12 EAST MELROSE ST. CHEVY CHASE
[HPC CASE # 35/13-12A]

SUBJECT: Historic Area Work Permit #594154, replacement of shutters, storm windows and other alterations

MONTGOMERY COUNTY HISTORIC PRESERVATION COMMISSION
STAFF REPORT

Address:	12 East Melrose Street, Chevy Chase	Meeting Date:	4/11/12
Resource:	Contributing Resource Chevy Chase Village Historic District	Report Date:	4/4/12
Applicant:	Michael Williams and Susan Gallagher	Public Notice:	3/28/12
Review:	HAWP	Tax Credit:	Partial
Case Number:	35/13-12H	Staff:	Josh Silver
PROPOSAL:	Replacement of shutters, storm windows, roof and other alterations

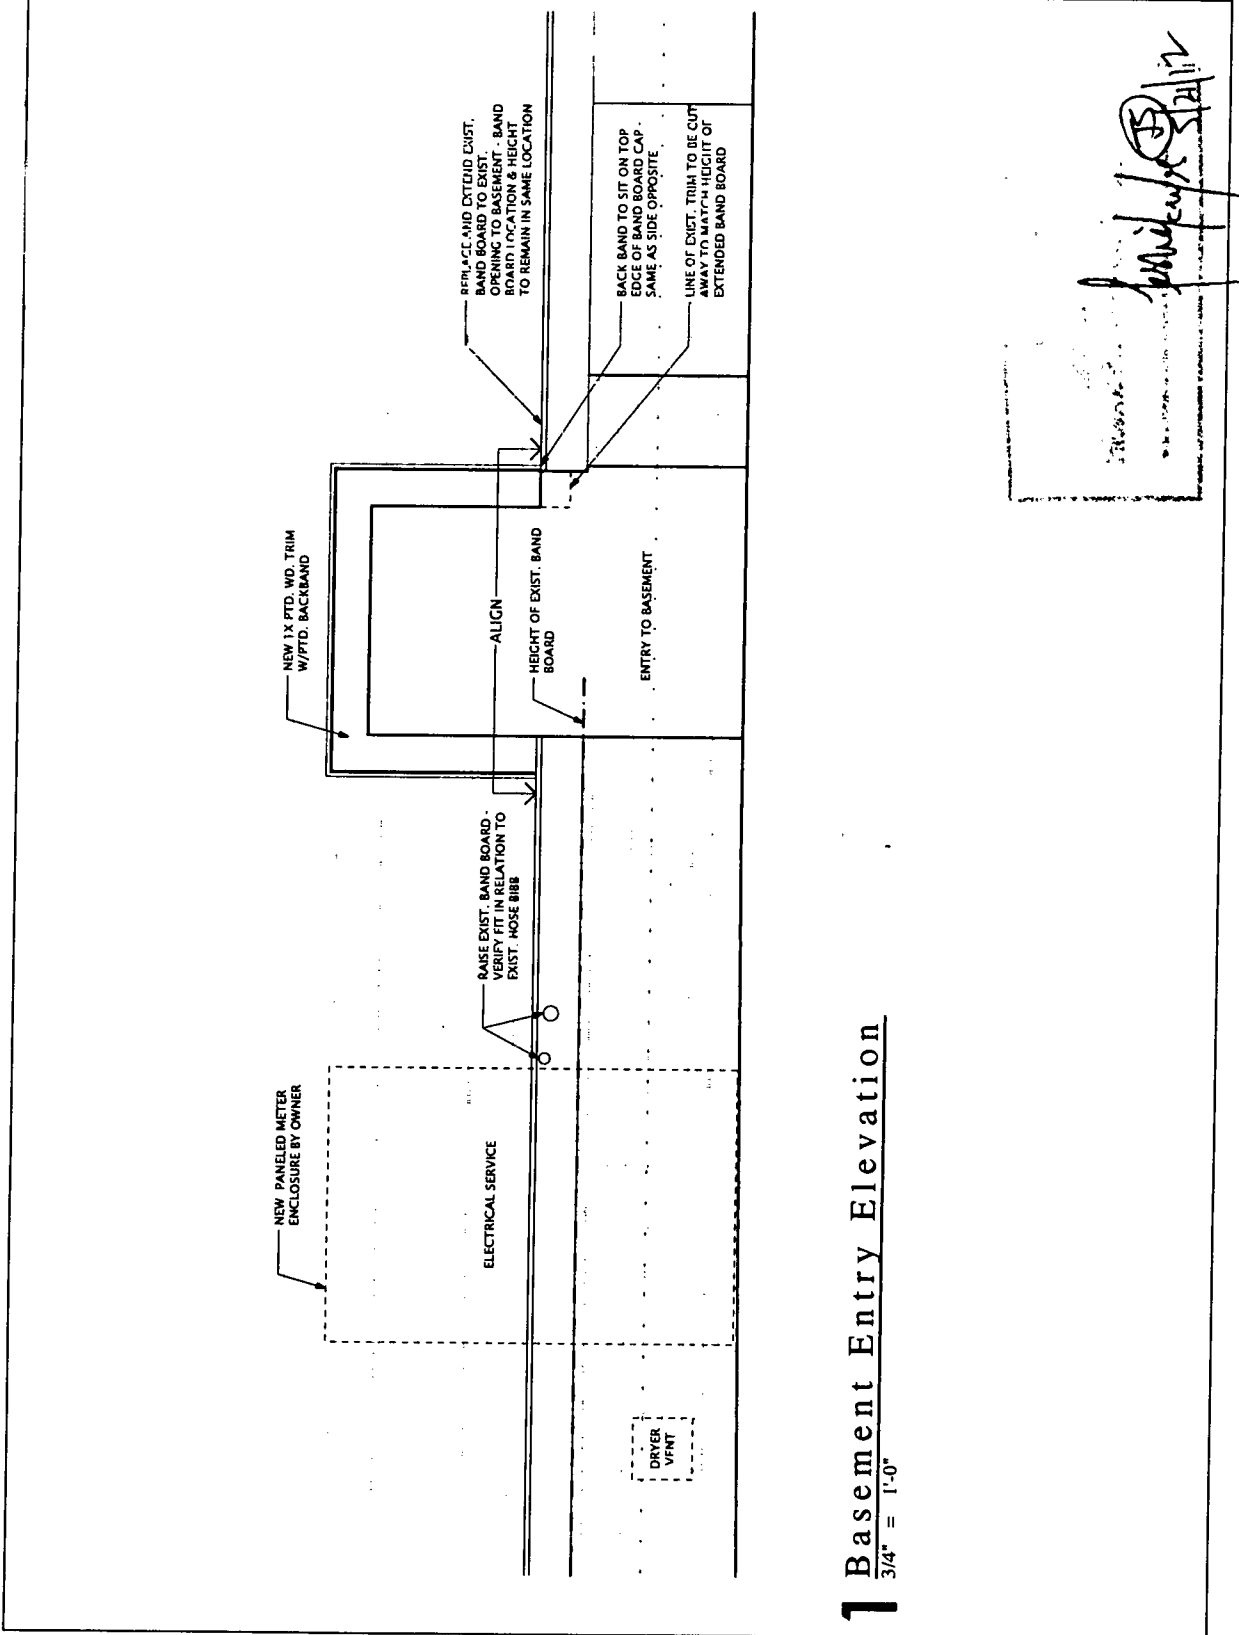
The main gable roof of the historic massing is visible from the public right-of-way. The proposed removal and replacement of a non-historic asphalt roof with an EcoStar recycled rubber and plastic "slate-like material" is a compatible new material. Consistent with the *Guidelines* materials differing from the original should be approved for contributing resources. The proposed installation of a "slate-like material" is a compatible new material consistent with the architectural style of the structure.

STORM WINDOWS
AND SHUTTERS

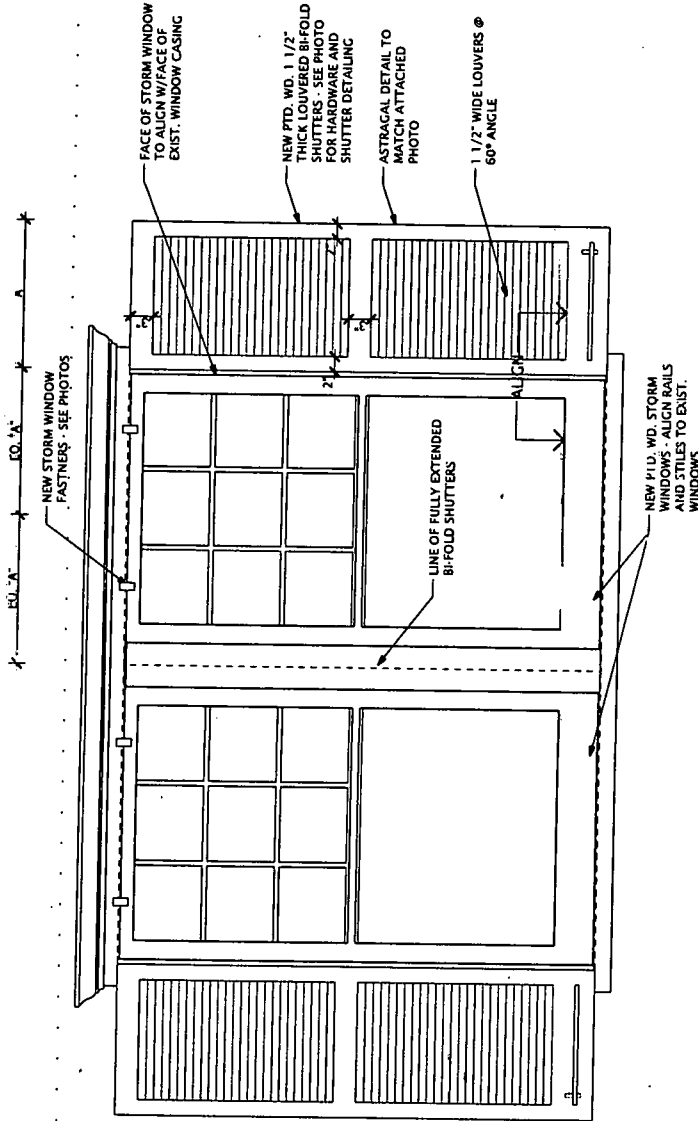
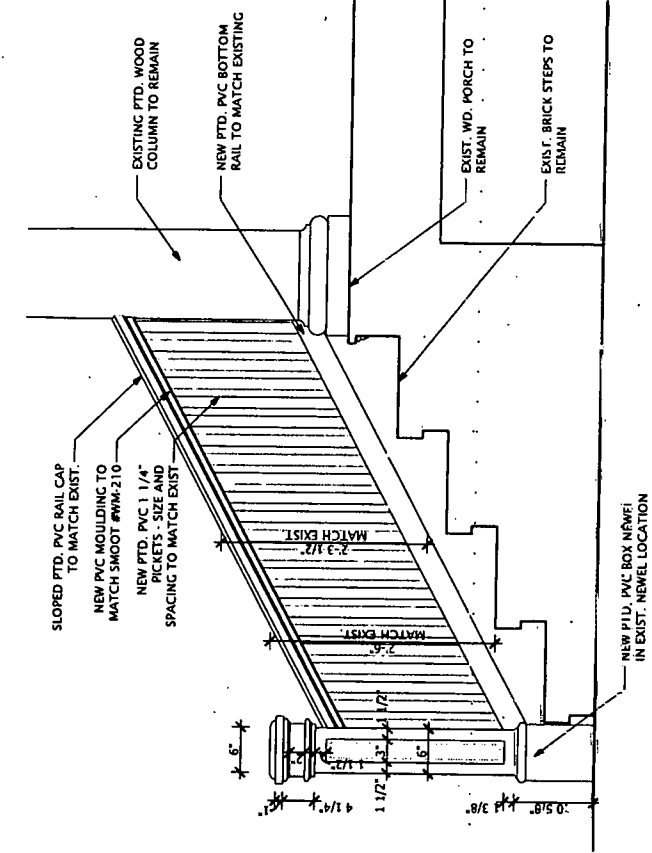
The proposed installation of wooden storm windows is compatible in character with the resource and historic district.

PORCH RAIL

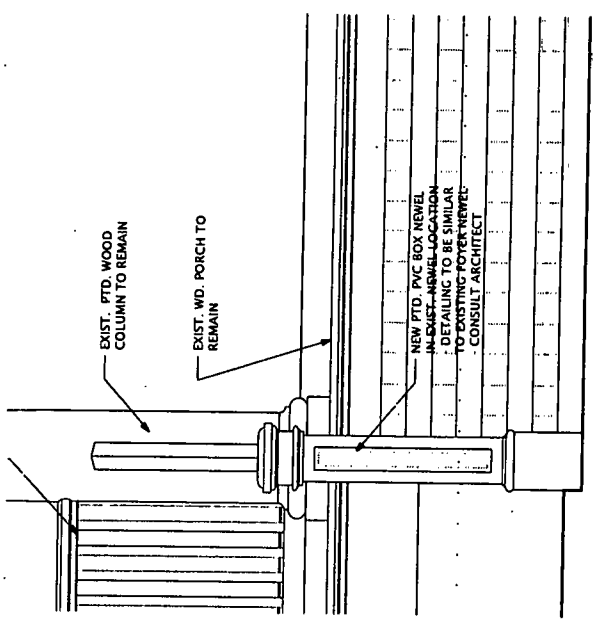
The front porch railing and newel posts are visible from the public right-of-way. The installation of a painted composite material front porch stair railing and newel posts in lieu of the existing wooden railing and posts is a compatible new material. Consistent with the *Guidelines* compatible new materials should be permitted. The proposed front porch stair railing style is consistent with the existing porch railing to remain and a box newel post is appropriate for the resource style, as such the integrity of the resource will be preserved and the altered structure will still contribute to the district.

Proposed Lantern at Front Porch:

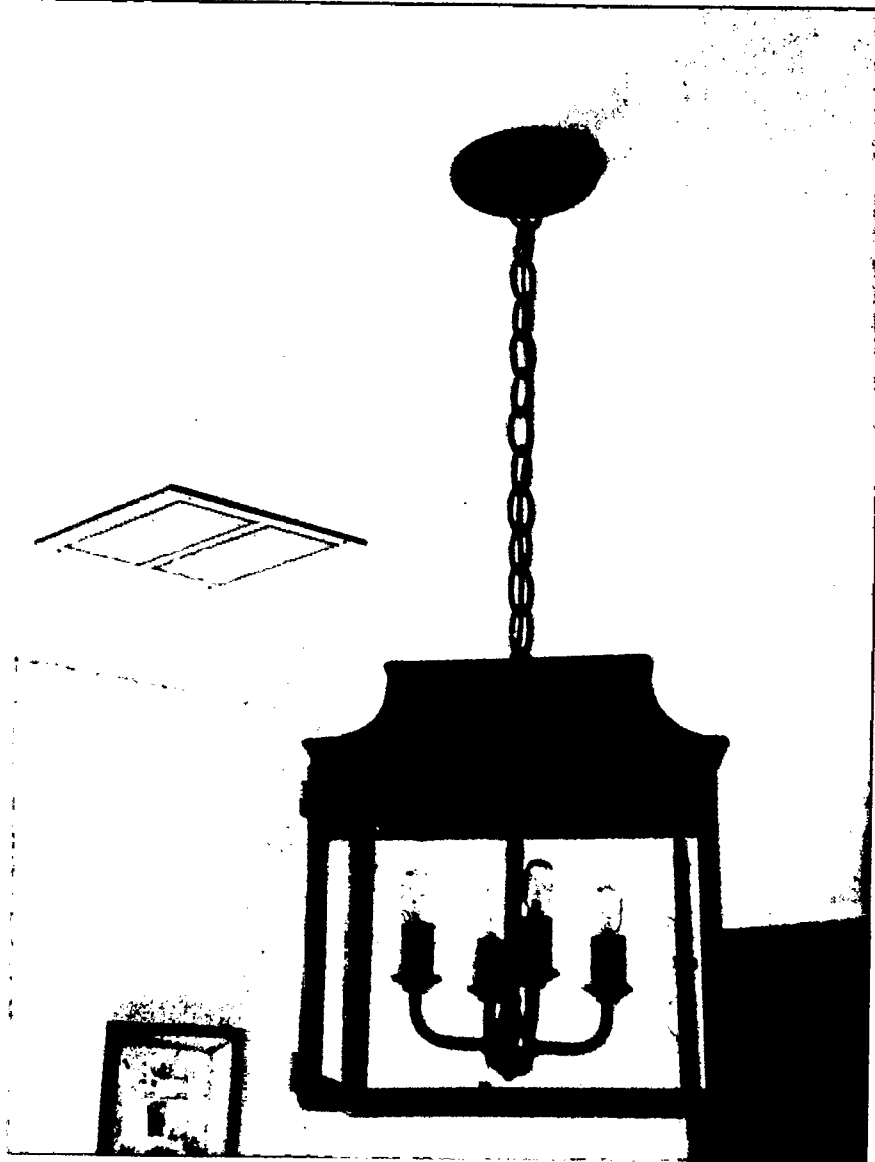
The existing hanging front porch light fixture is visible from the public right-of-way. The proposed hanging metal light fixture style is compatible with the structure's existing design.
